Appendix 1: Comparisons and photographs

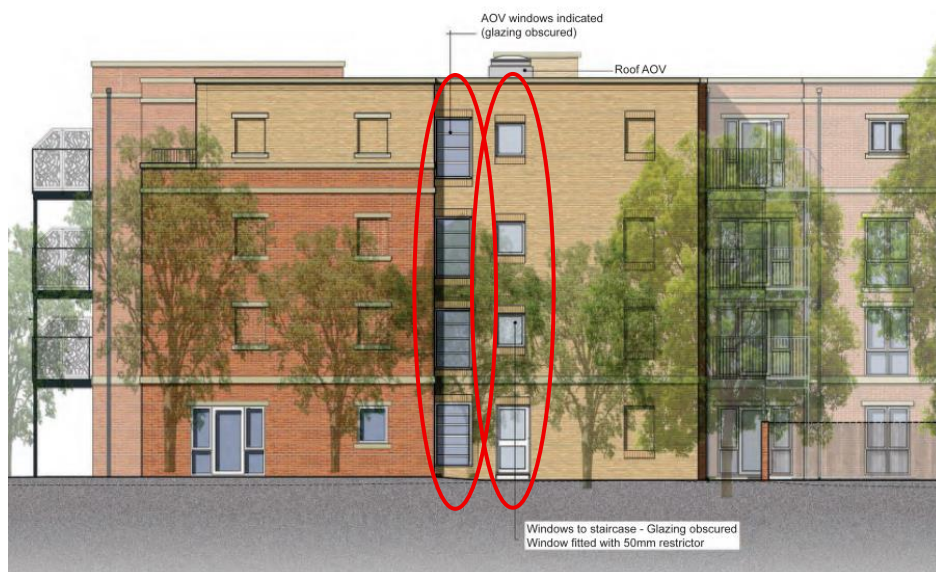
Larger windows and change to stairwell windows to the northern elevation:

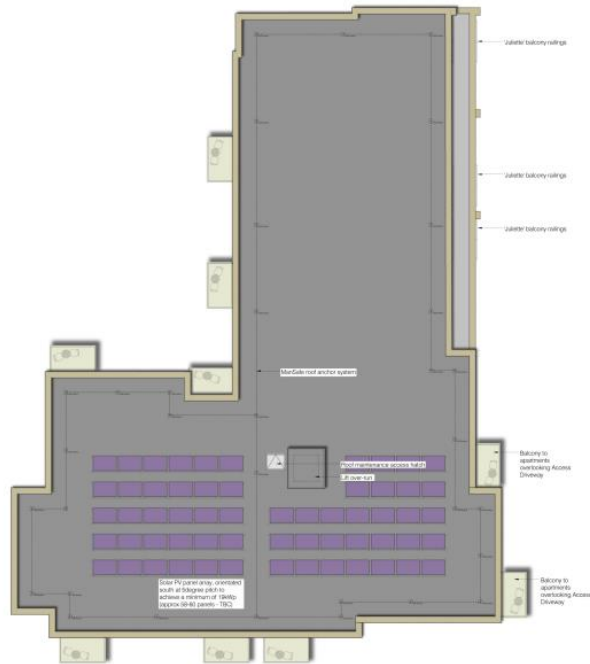
Plans updated to ensure consistency between floor plans and elevations plus safety railing added to eastern elevation

ROOF PLAN:

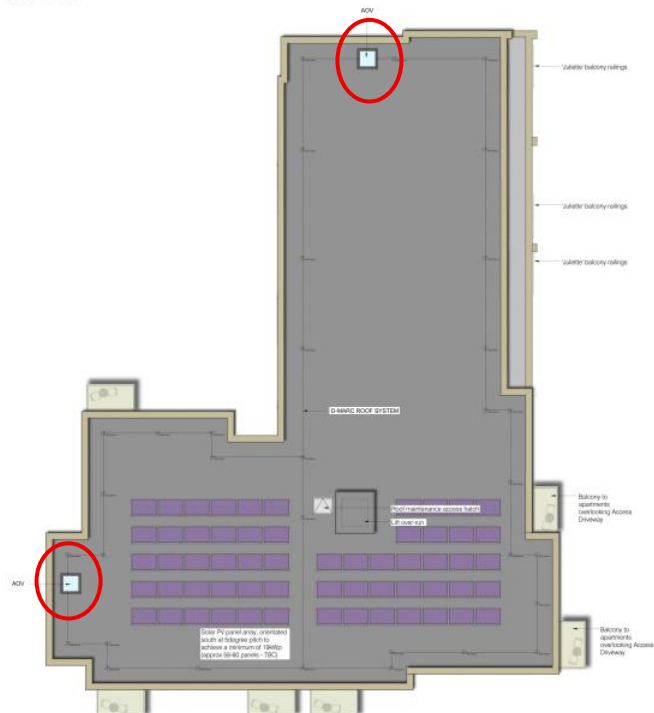
Addition of roof hatches:

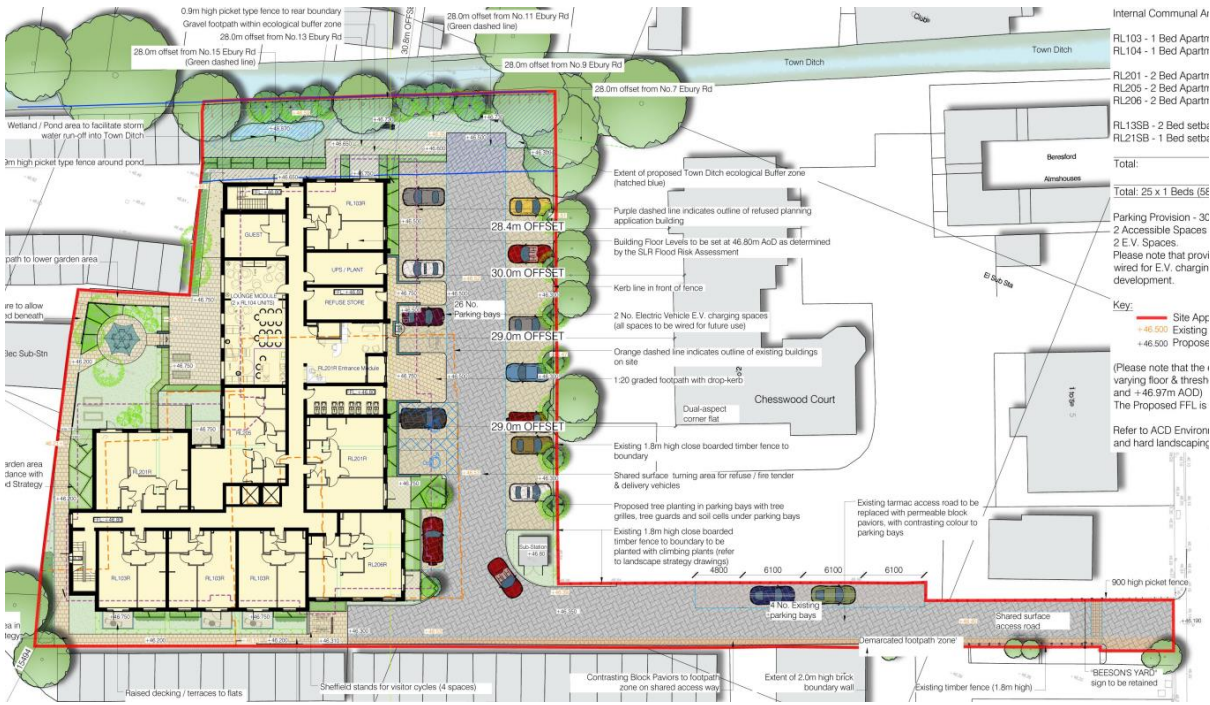
Omission of external stack balconies to western elevation and corner elevations:
